# COUNTY OF IMPERIAL

## GATEWAY COUNTY SERVICE AREA WATER TREATMENT PLANT IMPROVEMENTS

AUGUST 08, 2024

### ADDENDUM NO. 1

SHEET 1 OF 3

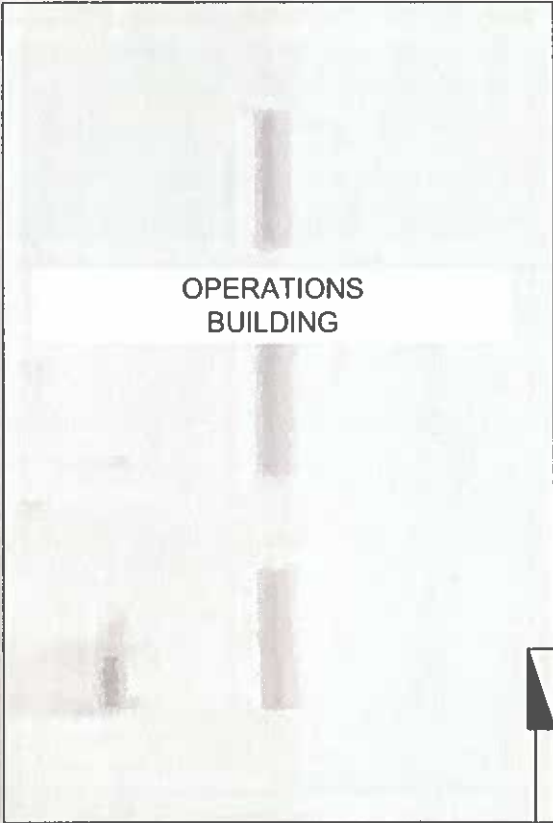
The IID CSP design documents – IID File 60127410 dated January 5, 2022 are hereby deleted and replaced with IID CSP design documents – IID File 60127410 dated July 31, 2024. The IID CSP design documents are referred to as the “Contractor Notes”.

The revised IID CSP design documents (Contractor Notes) – IID File 60127410 dated July 31, 2024 follow this Addendum Item.

REV.#	PG#	DATE	BY:	DESCRIPTION
1	3	11/02/22	LF	UPGRADED PANEL, PAD & CONDUIT.
2	2-3	07/31/24	A.B.	UPGRADED PANEL, PAD & CONDUIT.

REMOVE.  
EXISTING 600AMP  
SWITCHGEAR WITH CT  
METERING SECTION  
277/480V, 3-PHASE  
(BY CONTRACTOR)

REMOVE.  
EXISTING 8'X6'  
TRANSFORMER PAD  
COMPLETE  
(BY CONTRACTOR)

REMOVE.  
EXISTING 6-4"  
SECONDARY CONDUIT  
(BY CONTRACTOR)

PROPOSED 800AMP SWITCHGEAR WITH CT METERING SECTION 277/480V, 3-PHASE

INSTALL: 6-4" PVC SCHEDULE 40 SECONDARY CONDUIT (SEE SHEETS 108-120)

INSTALL 3Ø TRANSFORMER PAD #1244642 WITH OPENING WINDOW FACING EAST, RE-ENFORCE CONCRETE CURB & 4 BARRIER POSTS AS REQUIRED (SEE SHEETS 163-166, 168-171 & 174-175 FOR DETAILS)

# **EXHIBIT A**

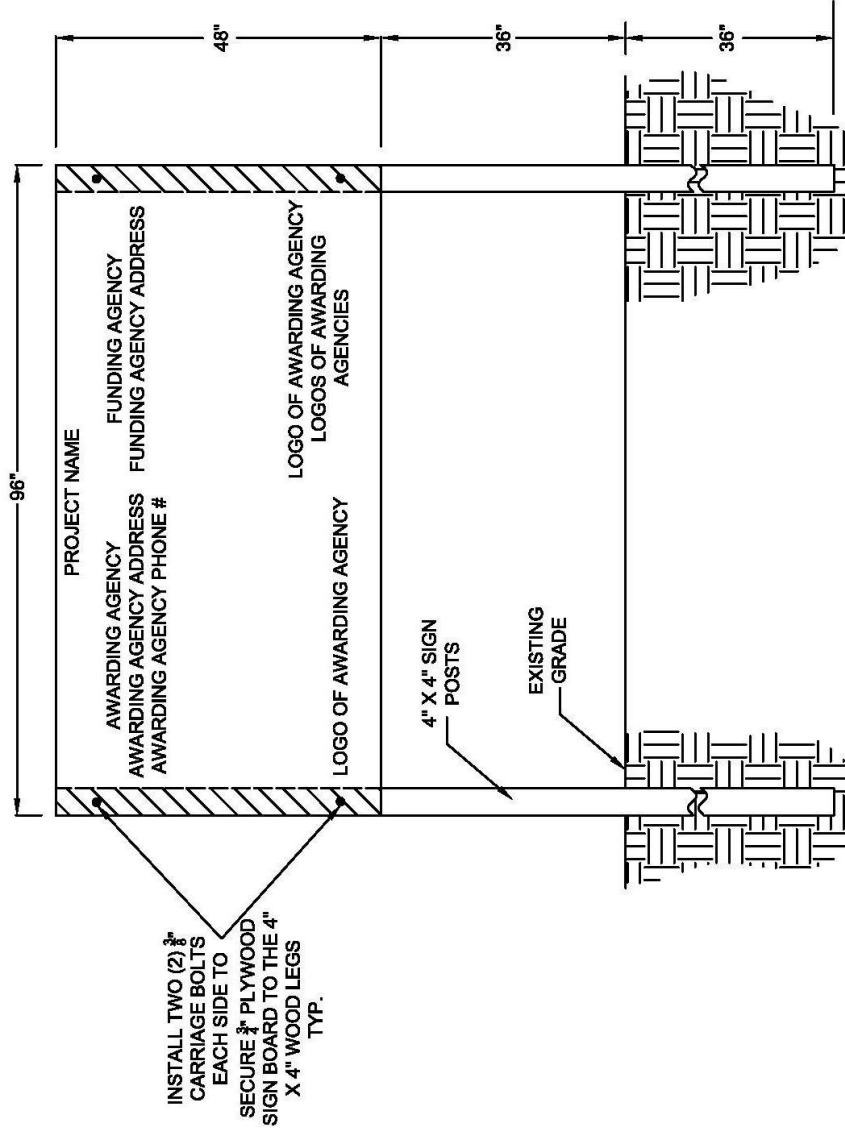
The *Project Identity Sign* shall be installed and mounted per *Exhibit "A" of the following this Addendum Item*.

- AT A MINIMUM PROVIDE THE FOLLOWING INFORMATION ON THE PROJECT IDENTITY SIGN
  - \* NAME OF THE PROJECT
  - \* AWARDING AGENCY
  - \* AWARDING AGENCY ADDRESS
  - \* AWARDING AGENCY PHONE NO.
  - \* AWARDING AGENCY LOGO
  - \* FUNDING AGENCY
  - \* FUNDING AGENCY ADDRESS
  - \* FUNDING AGENCY LOGO
- INSTALL FACING THE PUBLIC
